21 November 2013

Re: SSD 5897 – Remediation, land forming works, and general excavation works associated with the future basement area, Hickson Road, Barangaroo

TYPICAL PLAN

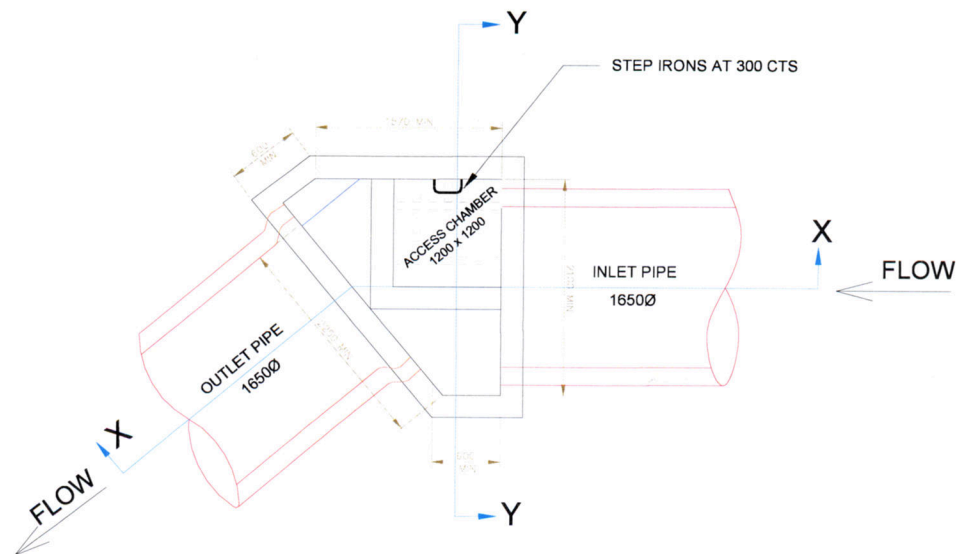
- Sydney Water requests the junction to Pit 13 meet the detail provided below. Alternatively all junctions to pits must not be at 90 degrees, preferably at minimum of 30 degrees. This ensures improved hydraulic performance, especially during flows approaching full pipe. While the plan below omits reinforcement for clarity, structural details will need to be included.
